ROANOKE COUNTY
WATER TREATMENT
FACILITY

FOOTING AND FOUNDATION PLAN	
PROJECT ARCHITECT RLJ/R	DESIGNATION NUMBER 1913
TECHNICIAN RJT	DATE 22 SEPT 1994

S2

INSPECTOR'S AS-BUILTS 1995
WWW.ID# 8LDLZ

SECTION S2.2
SCALE 1/2" = 1'-0"

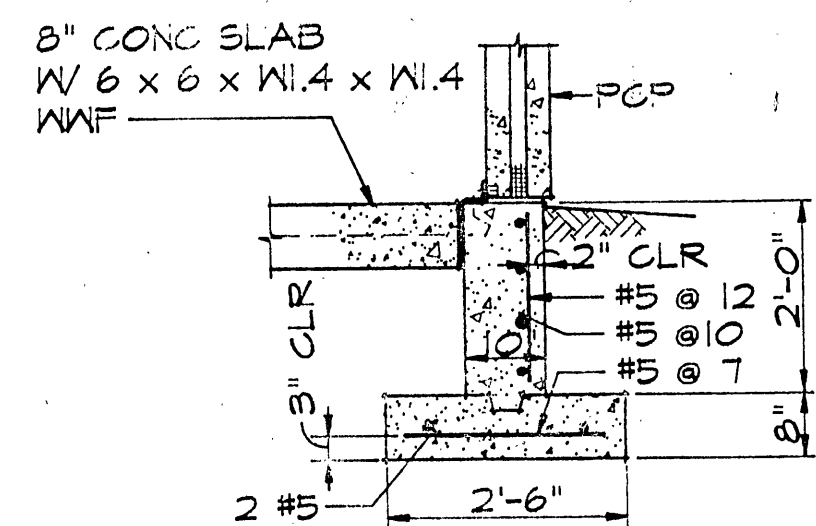
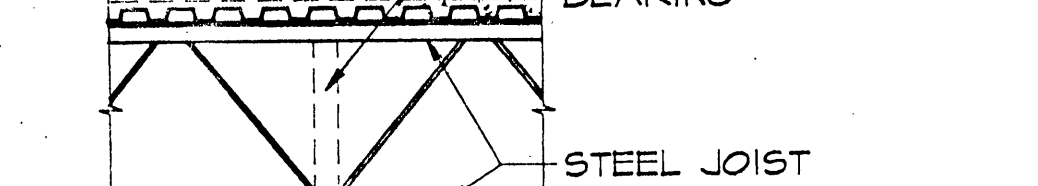
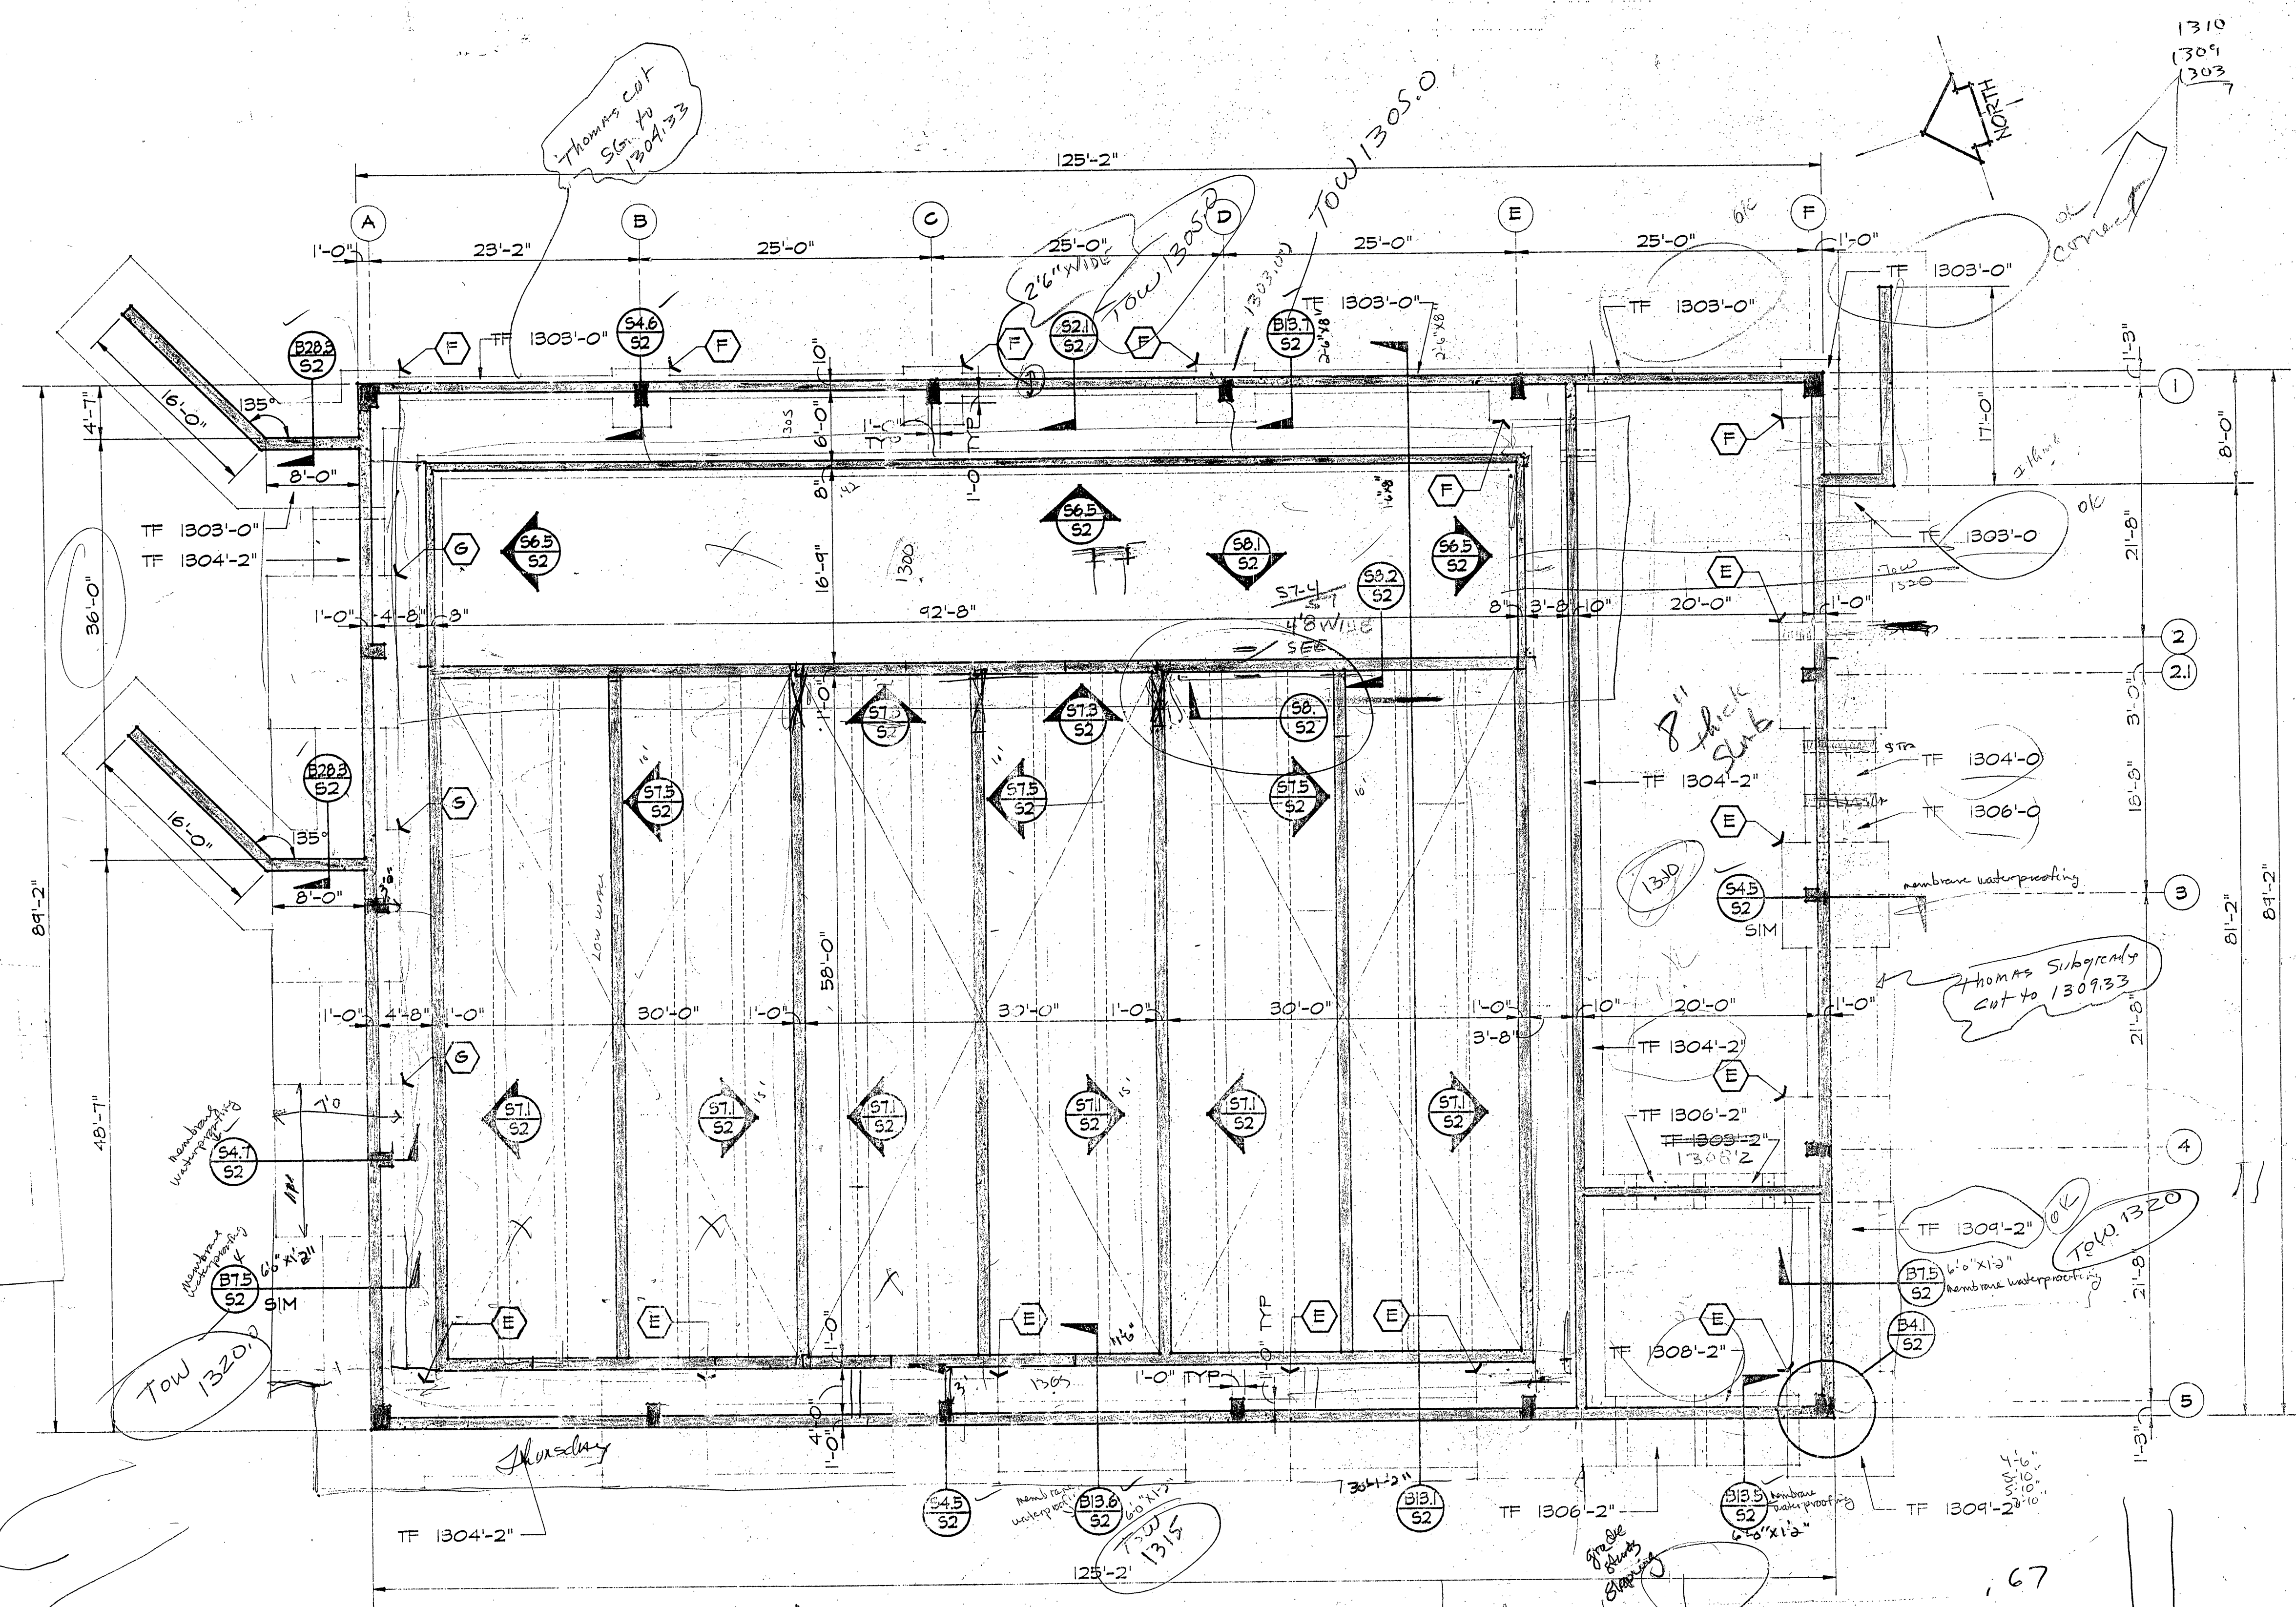
- ① DIMENSION CLARIFICATION - FROM OUTSIDE OF THE FOOTING CORNER TO EQUIPMENT ROOM 107 IS 68'-8"
- ② CLARIFICATION - DETAIL S2.2/S2 IS CORRECT. THE BEAMS ARE PERPENDICULAR TO THE STEEL JOISTS. THE JOISTS WERE MUST BE REINFORCED.
